Able Marine Energy Park

Material Change 2

Variation 4 Application

RE: APPLICATION FOR A VARIATION TO THE ABLE MARINE ENERGY PARK (AMEP) DEVELOPMENT CONSENT ORDER DEEMED MARINE LICENCE UNDER SECTION 72(3)(D) OF THE MARINE AND COASTAL ACCESS ACT

Figure 1: Consented Quay Alignment and Proposed Changes

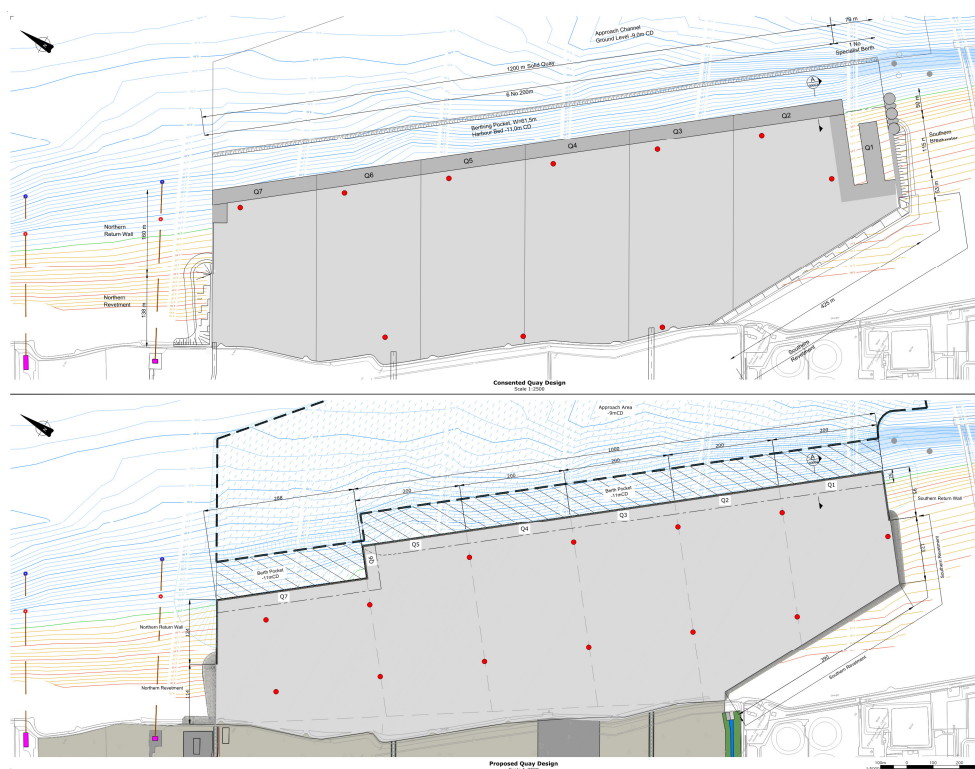
- The specialist berth at the southern end of the quay is to be reclaimed as the vessel that was to use the facility (refer to Figure 5.18 of the original ES) has not been constructed and is not likely to be built;

- Alternative details are proposed for the piled relieving slab to the rear of the quay which is shown on the approved drawing AMEP_P1D_D_003. Options are sought to locate this slab at the ground surface, or it could be omitted altogether subject to detailed design, refer to drawing AME-036-00003 at Appendix UES4-1 which illustrates the alternatives being sought; and,

- Alternative details are proposed for anchoring the quay wall. The option is sought to use more conventional steel anchor piles and tie bars in-lieu of flap anchors to tie back the quay piles, but the option to use flap anchors will remain, refer to drawing AME-036-00003 at Appendix UES4-1.

The net effect of changes (a) and (b) above is that marginally less land would be reclaimed from the estuary, refer to Figure 1. Nevertheless, no changes are proposed to the compensation proposals taken into account in the Secretary of State’s Habitats Regulations Assessment for the consented development. The change in habitat loss is summarised in Table 2 below, and the amendment results in a net reduction in the footprint of the quay from 45ha to 43.6ha. The changes are further detailed on drawings AME-036-00001 - 00002 at Appendix UES4-1.

Figure 2: Revised Indicative Cross Dam Positions in light red Shading (original dams in orange shading, Anglian Water outfalls as red lines)

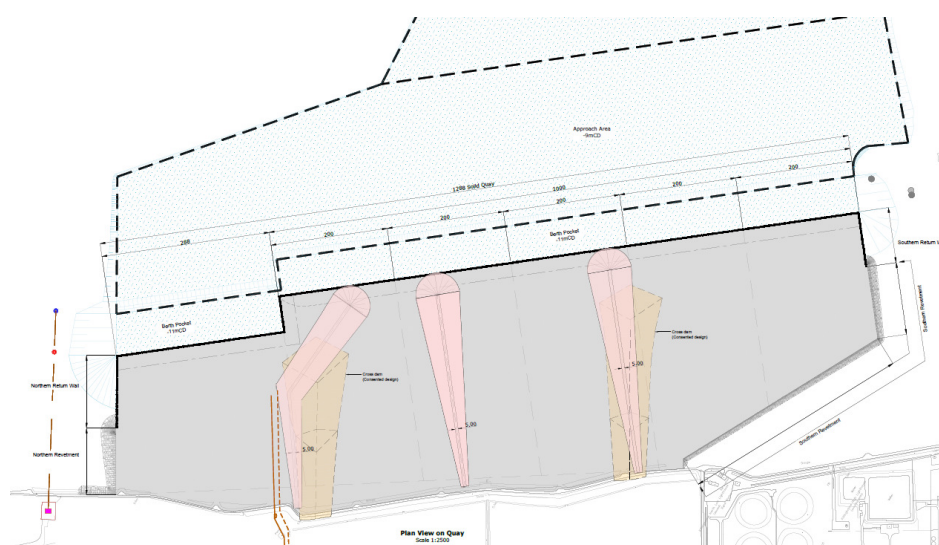
Certain details of the reclamation are prescribed in Schedule 8, paragraph 4 of the DCO (Technical Appendix UES1-1). Specifically, paragraph 4(f) states that the estuary, 'may be reclaimed using marine dredged sands and gravels by constructing two granular dams that extend from the existing flood defence wall to the area reclaimed..., so that the dams divide the remaining reclaim area into three approximately equal cells' (underline added).

Anglian Water has two pipelines which discharge within the footprint of the reclamation area between the existing flood defence wall and the new Quay wall refer to Figure 2. In order to facilitate the diversion of these outfalls, and to facilitate sectional completion of the Quay, it is necessary to introduce a third cross dam within the reclamation area. An amendment is sought to permit this change.
